Determination 2012/013

The issue of a building consent with a specified intended life for additions using a straw bale system to an existing house at 243 Ripponvale Road, Cromwell

- 2.3.1 The general construction of the addition is shown in the following sketch:

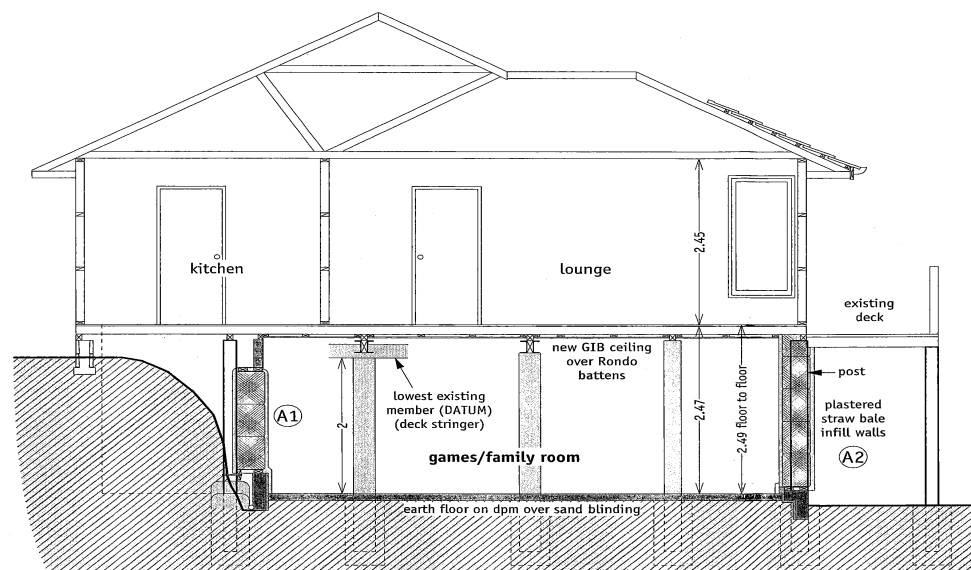
- 2.3.2 The straw bale infill walls are formed from 900mm x 455mm x 355mm straw bales tightly stacked on edge between the poles, forming mass walls more than 400mm thick, and it is proposed that moisture sensors will be installed within the bales. The straw bale walls are non-load bearing.
- 2.3.3 The specification for the straw bale walls and this determination refer to the set of Standards for earth buildings⁴ (“the earth standards”).

- 2.3.4 The straw bale walls are finished on both sides with a multi-coat plaster system that is about 40mm thick. The system consists of a slip coat, a body coat of earth (clay), sand and chopped straw, with a 'body coat' and two coats of fibre-reinforced lime plaster applied to all exterior and interior wall surfaces.
- 2.3.5 The northeast and northwest infill walls are largely sheltered by decks, with the southeast elevation sheltered by the existing block foundation wall and the building over hang. Two sections of wall to the northwest and southeast elevation not protected by decks have a 400mm wide steel cowling installed at the top of the infill walls that, in effect, provide eaves protection to the plastered walls beneath. The applicant has proposed to increase the cowl width to 600mm (refer paragraph 3.6).
